AAPM&R 2017 Annual Assembly and Technical Exhibition

Cursory ADA Facility Survey Report

May 11 and 12, 2016

Accessible ramp to the Wynkoop

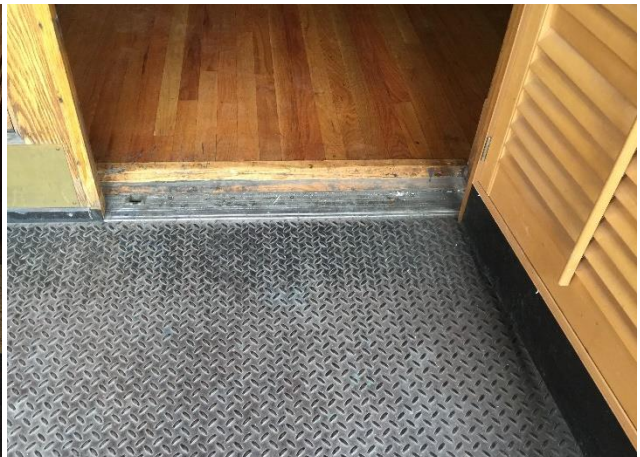
- The accessible route has several joints that have changes in level greater than $\frac{1}{4}$ " vertical or $\frac{1}{2}$ " maximum beveled. Recommend repairing these sections of pavement.

- The threshold at the accessible entrances are too high, need to be $\frac{3}{4}$ " high maximum with beveled edges. Recommend replacing with $\frac{1}{2}$ " high maximum thresholds.

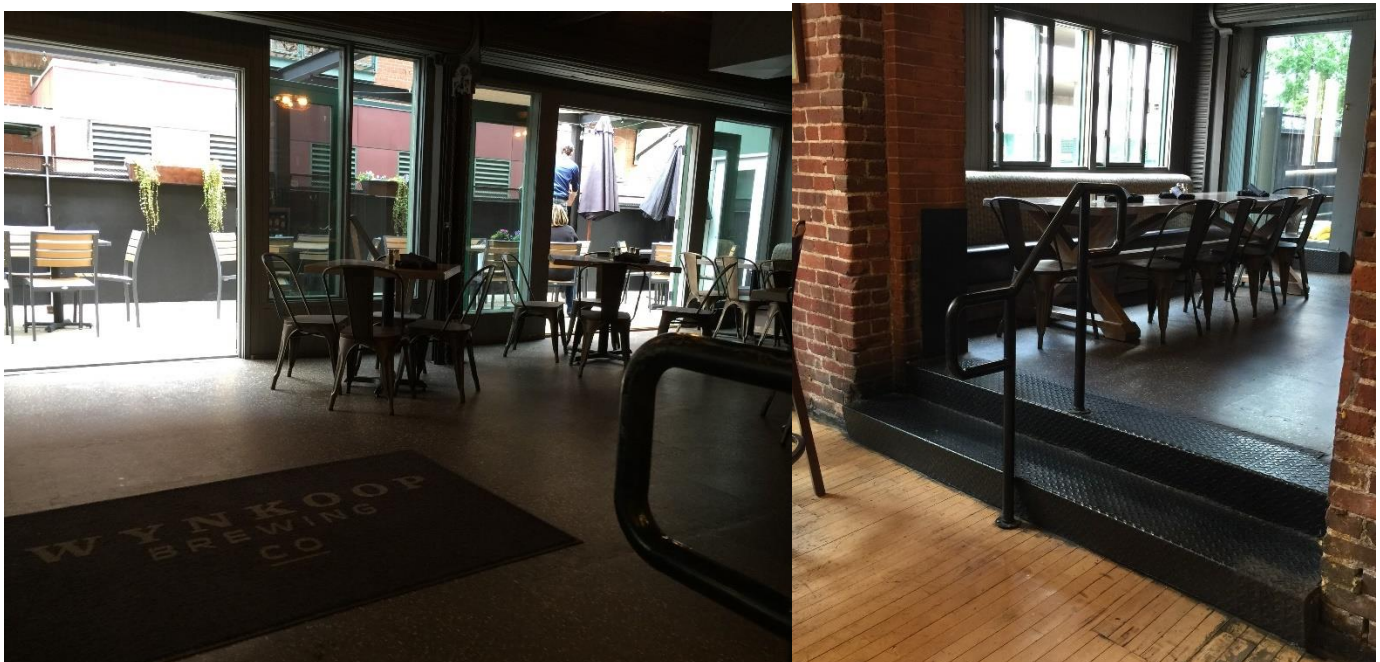
- The directional sign at the front entrance needs to be replaced, change wording to accessible entrance instead of handicap access.

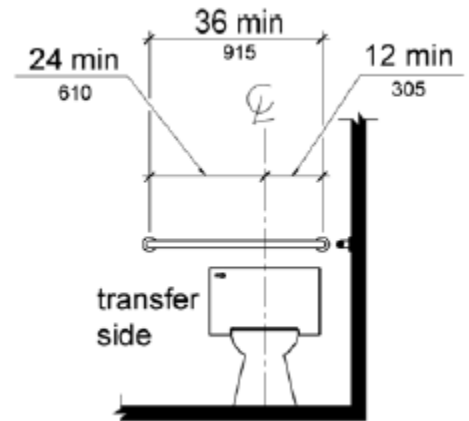
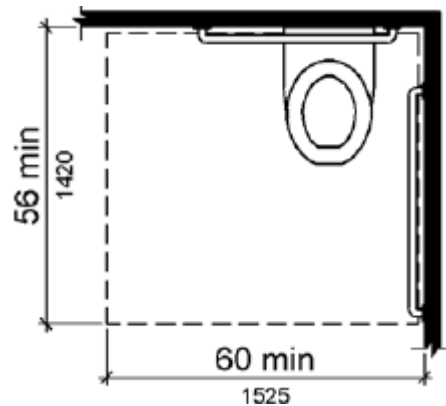
- The first floor accessible restroom does not meet accessibility requirements:
 - Required clear floor space at door is blocked by a chair and movable trash can. Remove chair from room and replace trash can with narrow version on the door side of sink.
 - Watch video link to understand all accessibility requirements needed in accessible restrooms, make sure cleaning and maintenance staff understand their role in maintaining access.

- There needs to be adequate clear space adjacent to the toilet for a side transfer. The new lavatory to be installed in this room should be moved closer to the side wall to provide the 60" required. Install a 36" grab bar along rear wall in place of the 24" existing.

- Soap and towel dispensers need to be lowered to 48" max. from floor to outlet.
- Wrap lavatory drain pipes.
- The mirror is hung too high. Lower to 40" maximum above floor.

One of the light rail crossings from Embassy Suites to the Convention Center

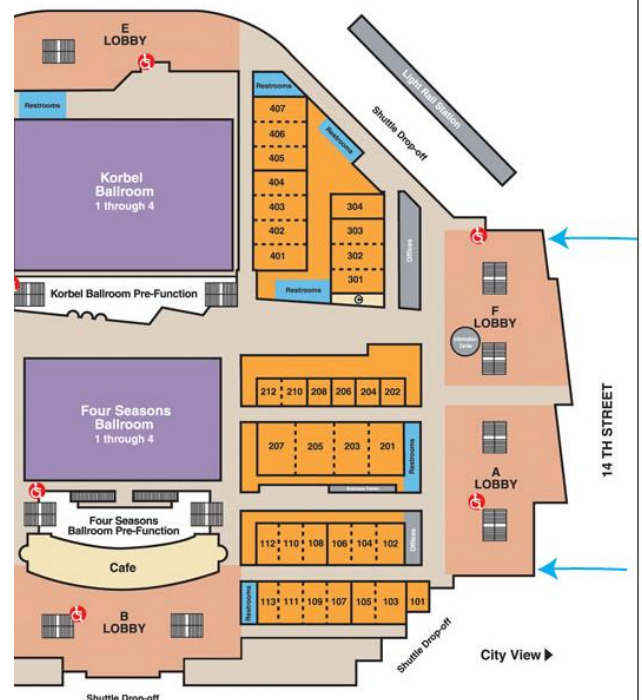
- The accessible route to the convention center from this hotel requires crossing two sets of light rail tracks. They are compliant with tactile warning strips on each side, rail gaps are approximately 3" wide.

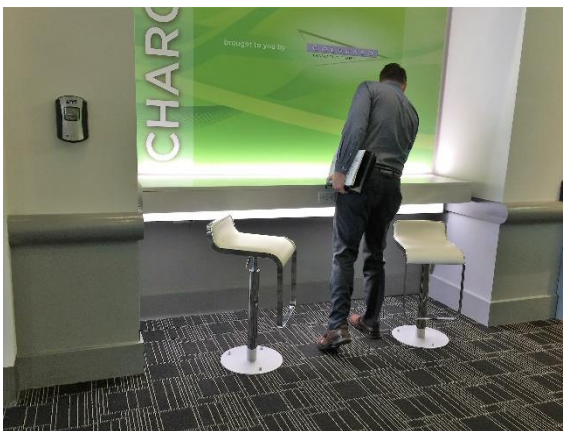
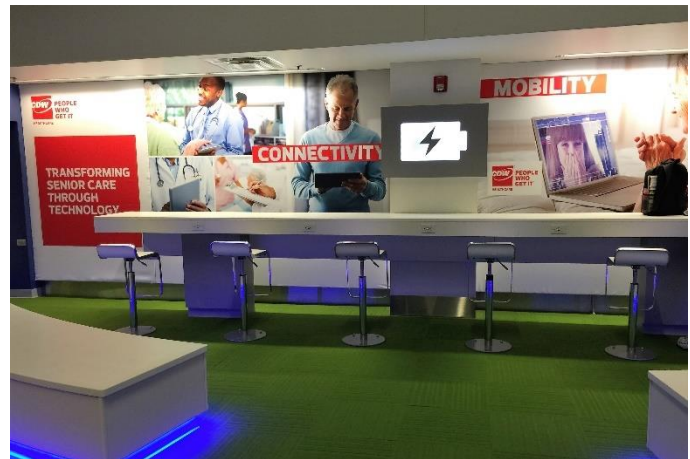
- Charging stations do not include an accessible work surface. Add at the left end of these stations with charging outlet.

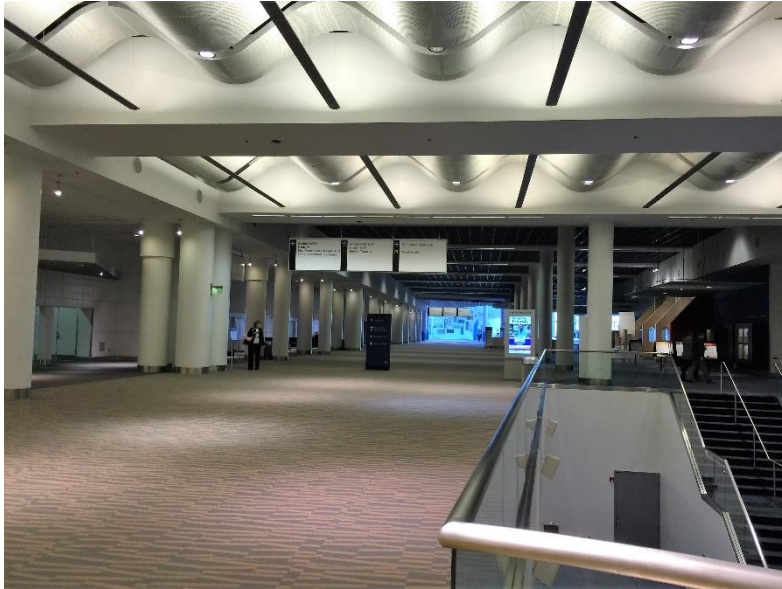
- Lower the height of one of these charging stations in the 700 hall to meet accessible work surface requirements, keep one space clear of seating for wheelchair use.

Elevator location to access ballroom

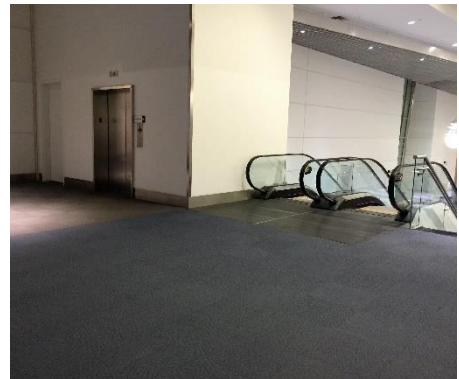
- Lower the height of the hand sanitizer adjacent to accessible charging station so that the outlet is 48" above the floor maximum.
- The elevators in the Center are not located in the central corridors with the escalators and stairs. Provide directional signage easily visible from the stair/escalator entrances. The wheelchair symbol on the maps should include an elevator symbol as well to clarify for cane users, people with strollers, etc.

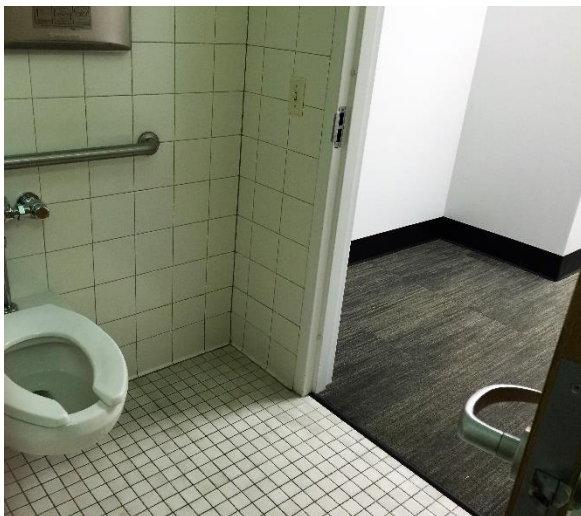
- Most of the restrooms in the Convention Center are accessible, signage with wheelchair symbol are not provided and not needed as all are accessible.
- The mezzanine has three single user restrooms, none of them meet ADA requirements. The restroom to the right as you exit the elevator includes an inaccessible shower, inadequate clear floor space at door and toilet (a wheelchair user cannot close the door). Recommend this restroom be replaced with an accessible restroom when alterations are made.

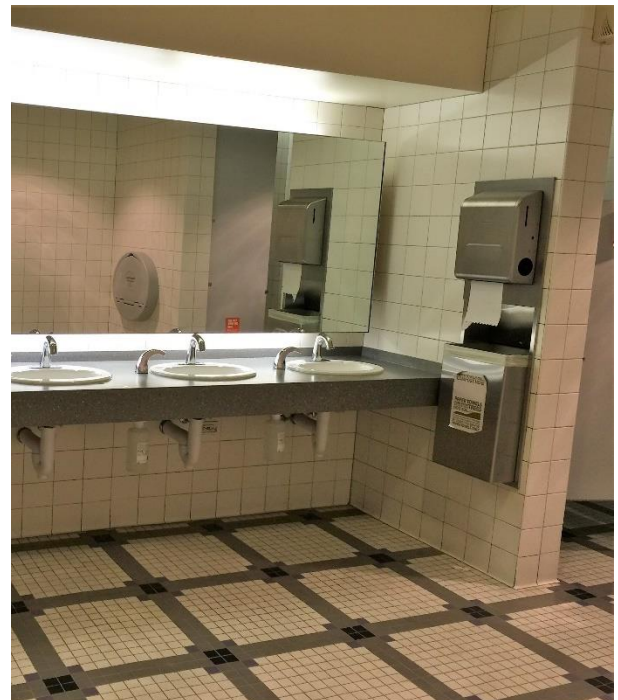
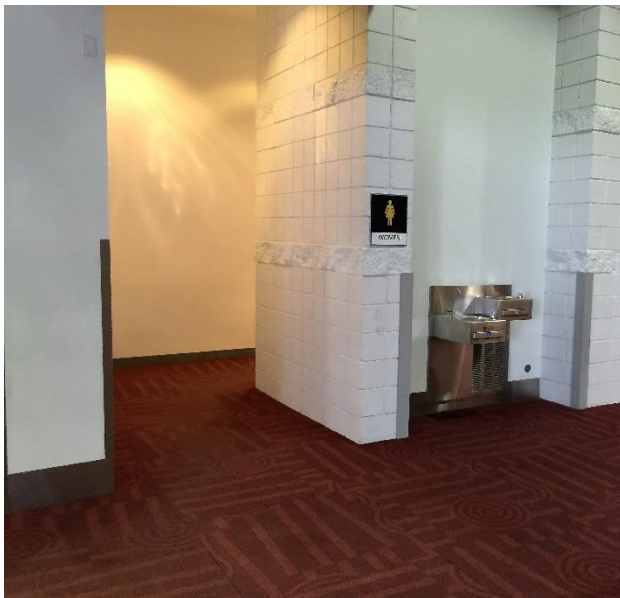
- The men's restroom on the mezzanine level does not meet ADA requirements.
 - Toilet is too far from wall
 - Urinal blocks transfer area to toilet.
 - Toilet cover dispenser is too high
 - Toilet paper dispenser sticks out too far.
- Provide a compliant toilet room when space is altered.

- The women's restroom on the mezzanine level does not meet ADA requirements.
 - Lavatory drain pipes are not wrapped
 - Lavatory blocks transfer area to toilet.
 - Toilet cover and soap dispenser are too high
 - Toilet paper dispenser sticks out too far.
- Provide a compliant toilet room when space is altered.

Elevator location for Belco Theater

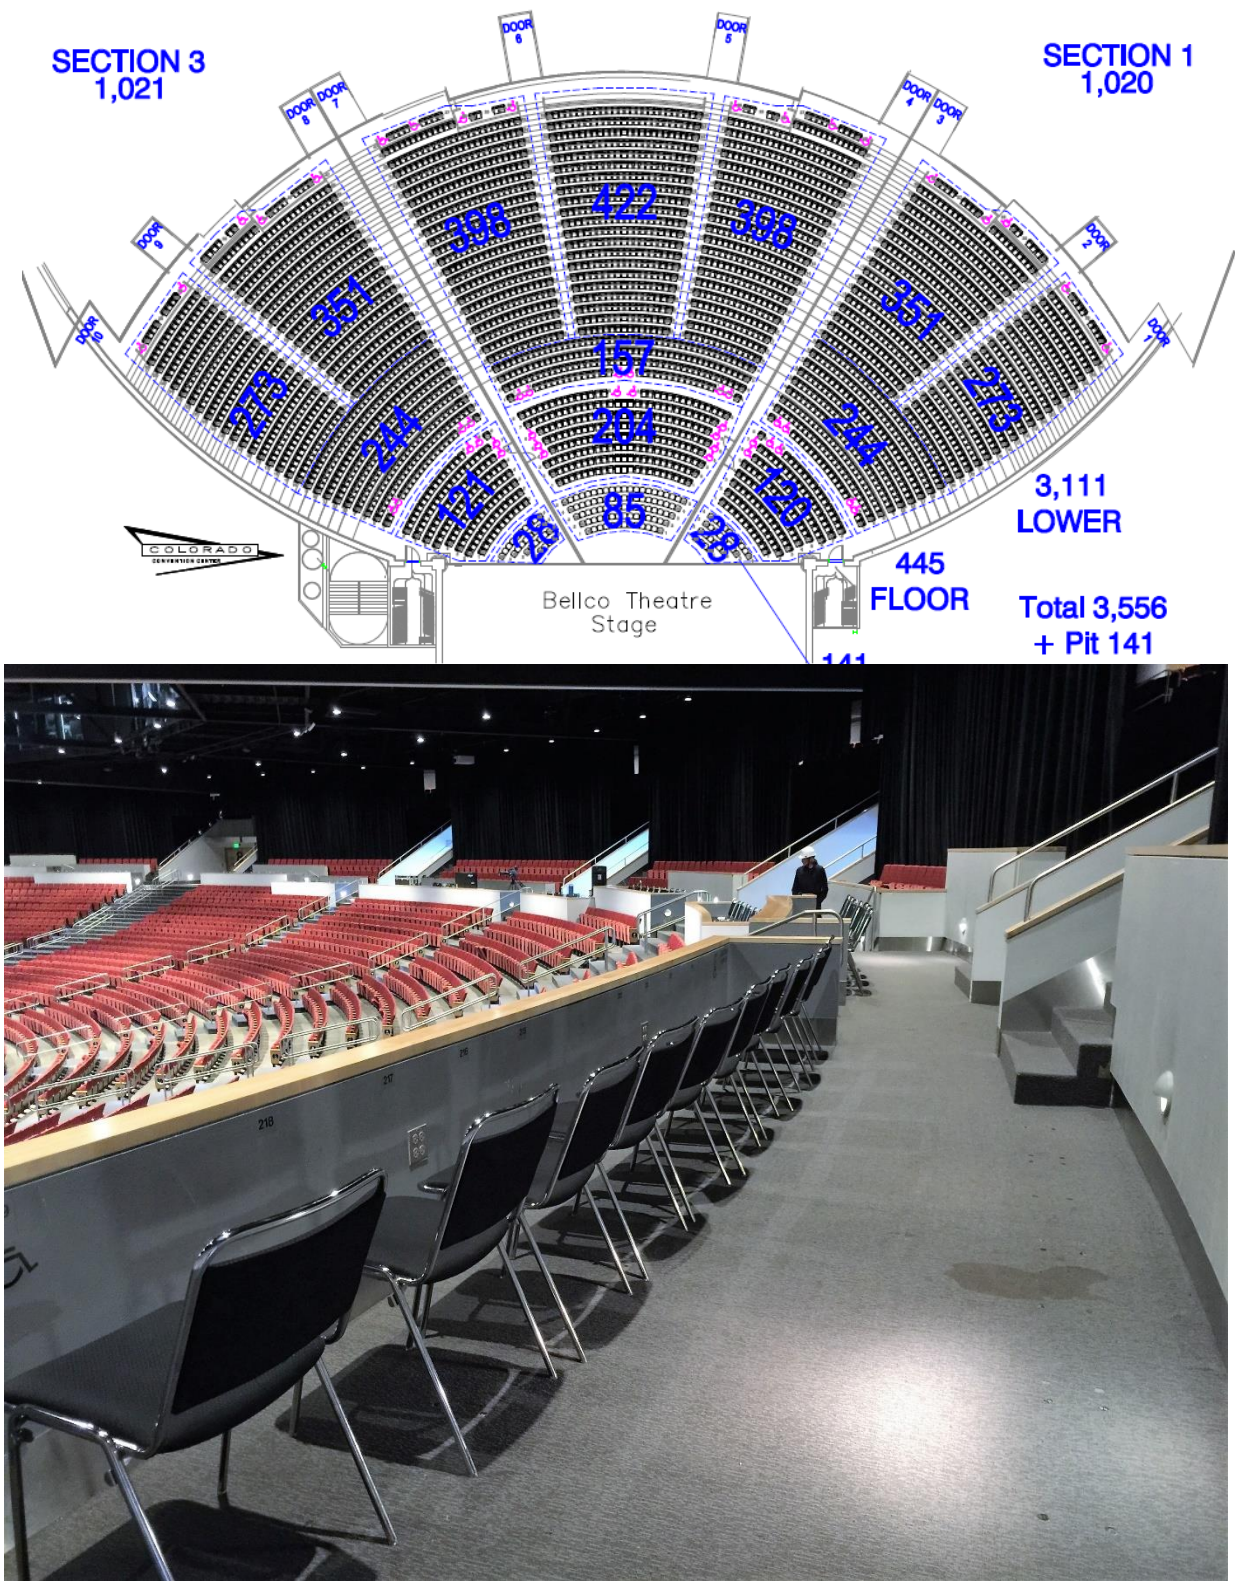
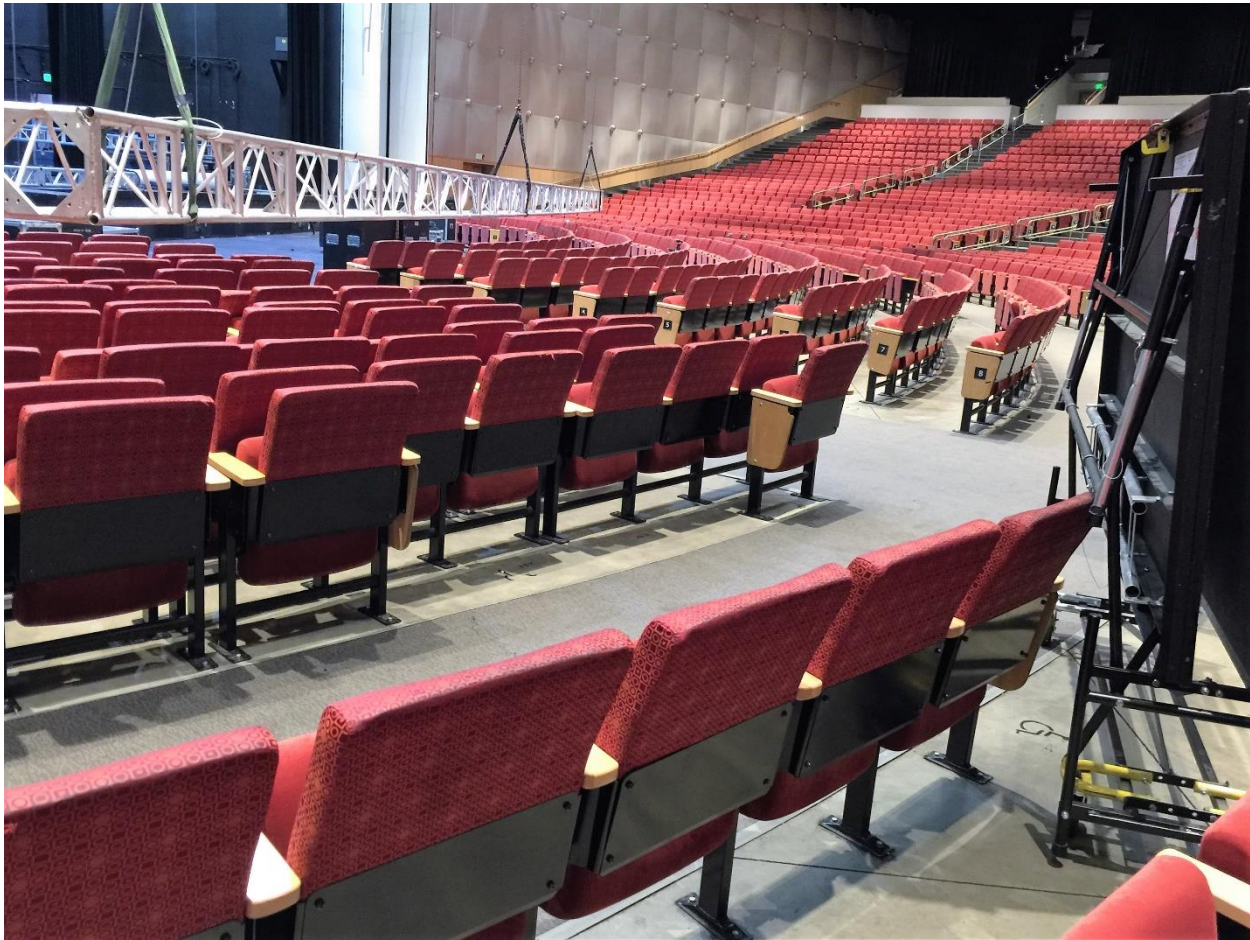
- The accessible route to the lower seating areas is by a single elevator that also serves the stage and speaker/talent green room areas.
- The elevator is not visible from the lobby and size of the signage makes it difficult to find in this expansive space. This is likely not an issue for ticketed events where patrons are directed to seating, however, for open seating events, the accessible route is difficult to find. Recommend increasing size of signage.
- The elevator is required to be available for anyone to use.
- Seating charts need to show the accessible route to the accessible seats. The route to seating areas 2 and 3 is through this elevator and through Section 1. Describe how dispersed seating is provided in Sections 2 and 3 when the theater is sectioned off and multiple programs are taking place. The ADA does not

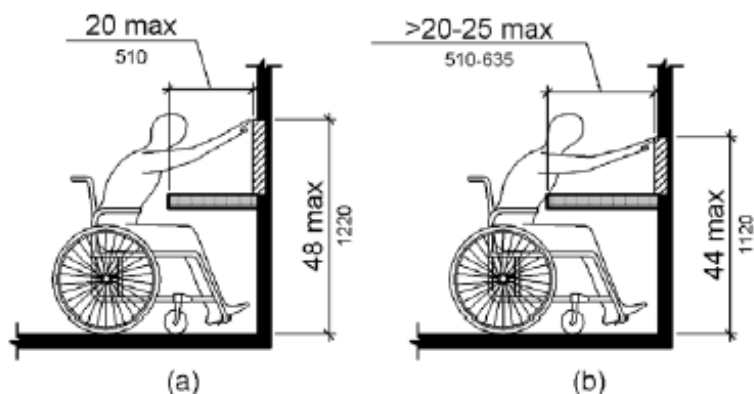
- Paper towel dispensers are too deep in the counter. Recommend placing a towel dispenser on counters behind trash hole. 25" maximum from front edge of counter.
